## PLANNING COMMITTEE - 8 OCTOBER 2019

19/01288/FUL

Proposal: Replacement of existing house with new dwelling

Location: Horstead, Station Road, Bleasby, Nottinghamshire, NG14 7GH

OS Map 1900

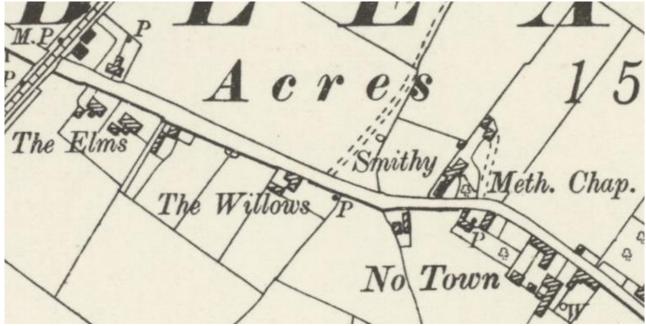
The property reflects the local vernacular, however it has been extensively altered. However, the simple single pile cottage with two fireplaces and what appears to be a later bay to the south. Although the building has some historic interest, its architectural significance has been eroded due to these modern alterations. Significant alterations would be necessary to restore the building with its traditional detail. Unfortunately this area of Bleasby has been seen significant development since the end of the 19th century. The cottages agricultural context has been eroded.

Due to the loss of its traditional architectural detail and historic context the building is not considered to be a non-designated heritage asset. However, due to the historic interest that has been identified this building should be recorded prior to demolition.
